**Date:** 24 April 2009  
**To:** ALL BIDDERS  
**Subject:** Addendum

**ADDENDUM # 003**  
**Tender # STPA2008S-30**  
**PART A - CO8 - Coke Oven Water Treatment Plant &**  
**PART B – CO7 – Coke Oven Groundwater Collection System**  
**for the Sydney Tar Ponds Agency**

Remediation of the Tar Ponds and Coke Oven Sites  
WATER TREATMENT PLANT AND GROUND WATER  
COLLECTION SYSTEM

Part A - Project Element CO8  
FILTER VESSEL DRAIN CONNECTION  
REVISION

CO8-DWG-P01-AD1

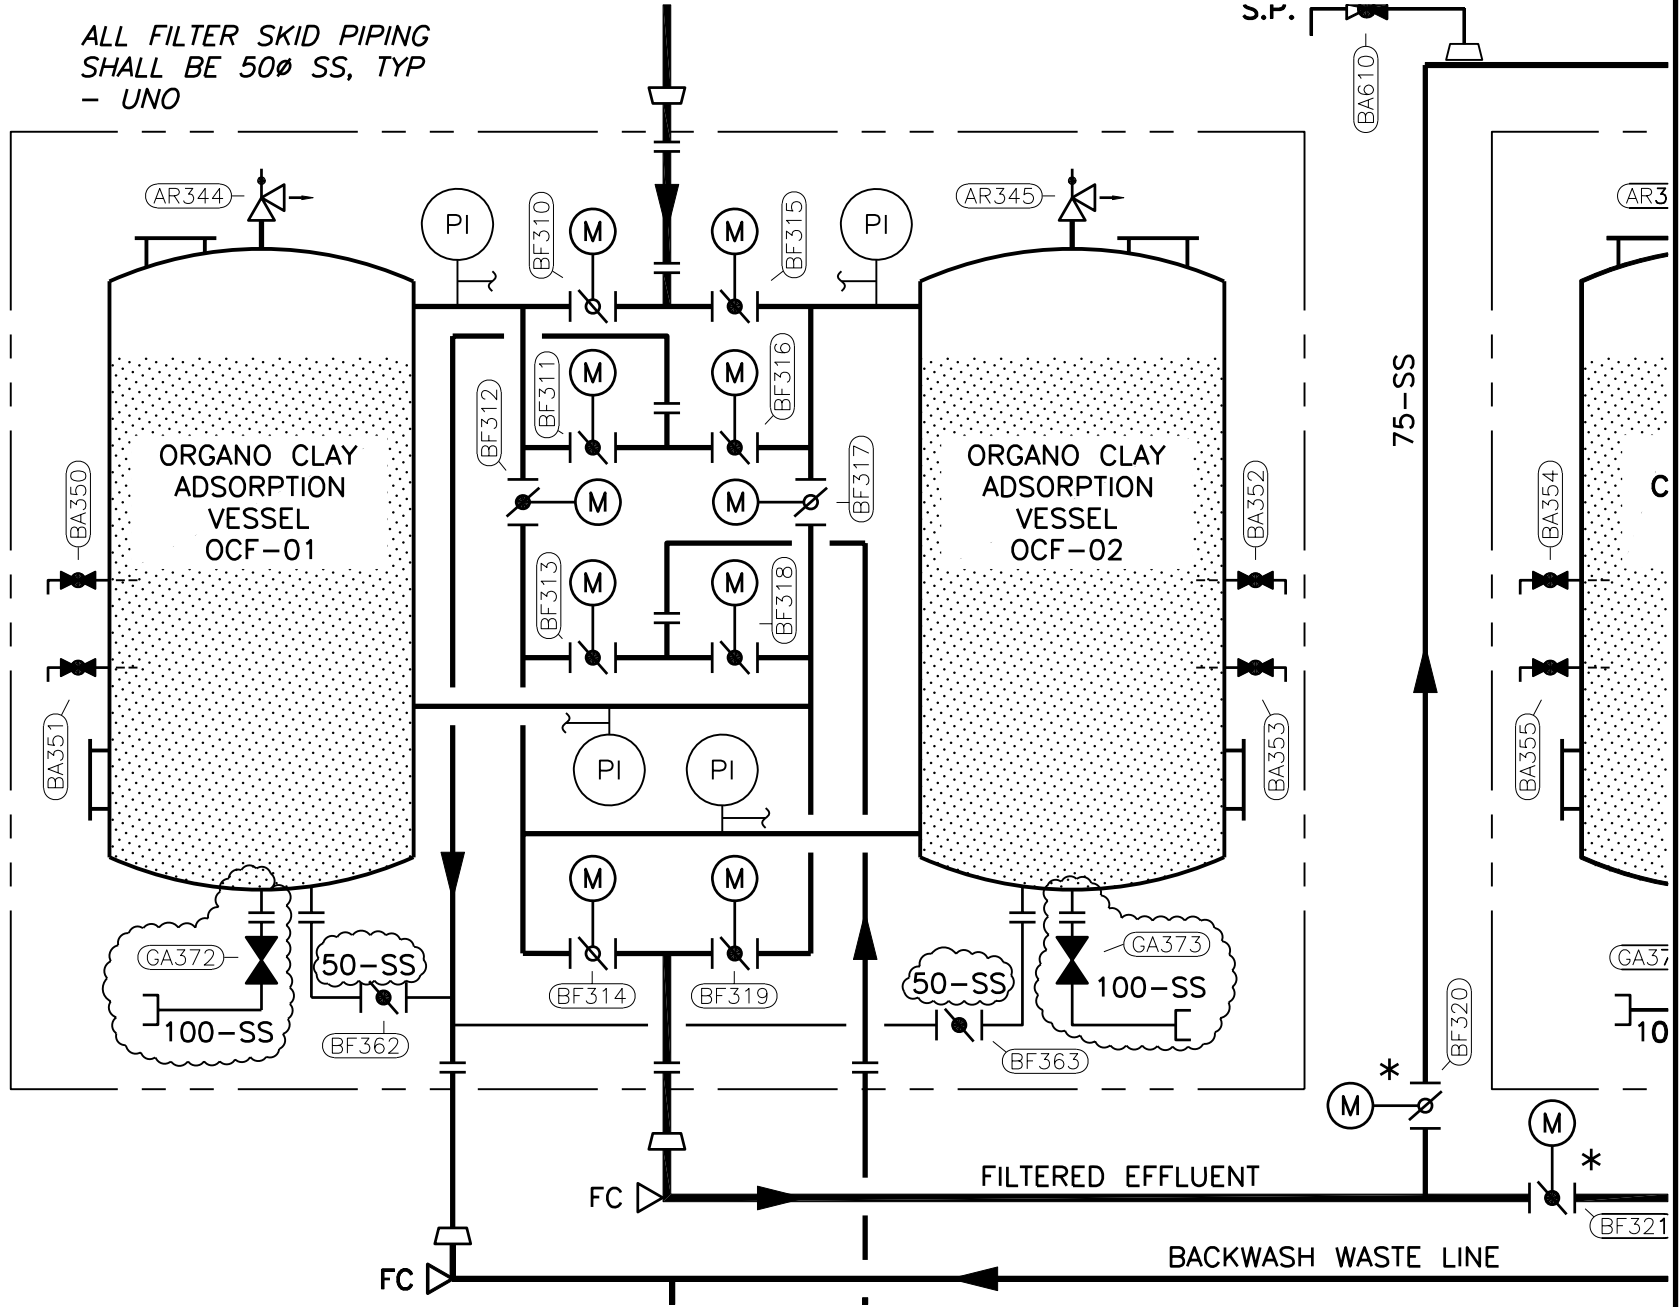
SECTION 44 41 13 PACKAGE WATER TREATMENT SYSTEM 3H) Item 2.4.2.19 - Please see the attached sketch for bottom connections. Provide one (1) 50mm connection (with screen) for draining as well as one (1) 100mm connection (valved with coupling) for draining.

ALL FILTER SKID PIPING SHALL BE 50Ø SS, TYP - UNO
